This errata sheet provides updated information on known device issues affecting Cyclone® IV devices.

Table 1 lists specific Cyclone IV issues and which Cyclone IV devices are affected by each issue.

Figure 1. Programmable PPM Detector Options in the ALTGX MegaWizard Plug-In Manager

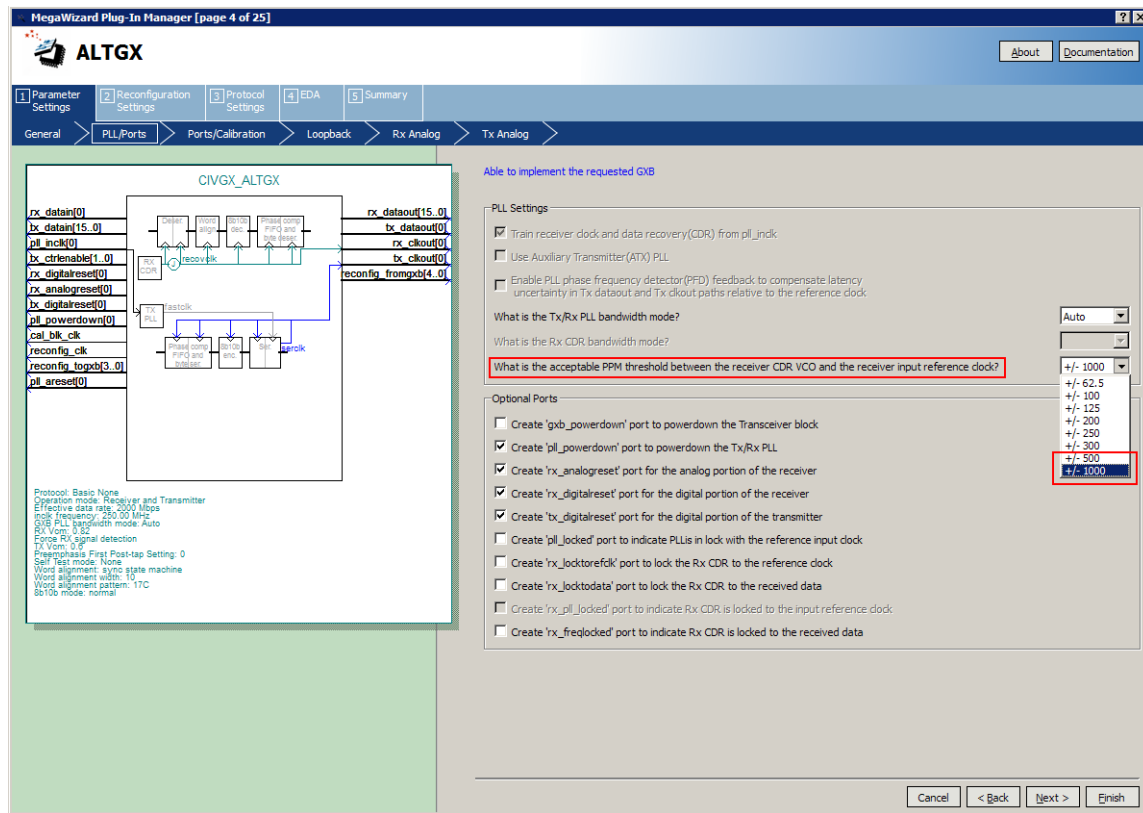
The  $\pm 500$  PPM and  $\pm 1000$  PPM options for the Programmable PPM Detector feature in the ALTGX MegaWizard™ Plug-In Manager, as shown in [Figure 1](#), are no longer supported in the Quartus II software version 10.0 SP1 and later. These options are removed because the programmed PPM threshold values exceed the receiver CDR PPM tolerance between the upstream transmitter reference clock and the local receiver reference clock.

Designs compiled with the Quartus II software version 10.0 and earlier may have a link failure risk when the receiver is operating in a system that has  $\pm 500$  PPM or  $\pm 1000$  PPM differences for the reference clock frequencies between the upstream transmitter and the local receiver. Using CDR Manual Lock mode does not overcome the link failure risk.

For a receiver design that has the  $\pm 500$  PPM or  $\pm 1000$  PPM options selected in the Programmable PPM Detector feature, Altera recommends evaluating the system operation with different options, ranging between  $\pm 62.5$  PPM and  $\pm 300$  PPM. To change the **Programmable PPM Detector** option, regenerate and recompile the ALTGX MegaWizard Plug-In Manager design file with the supported options.

If you compiled your designs using a Quartus II software version prior to 10.0 SP1, and you have selected the  $\pm 500$  PPM or the  $\pm 1000$  PPM option for the Programmable PPM Detector feature, the Quartus II Analysis and Synthesis error will be reported in the Quartus II software version 10.0 SP1 and later.
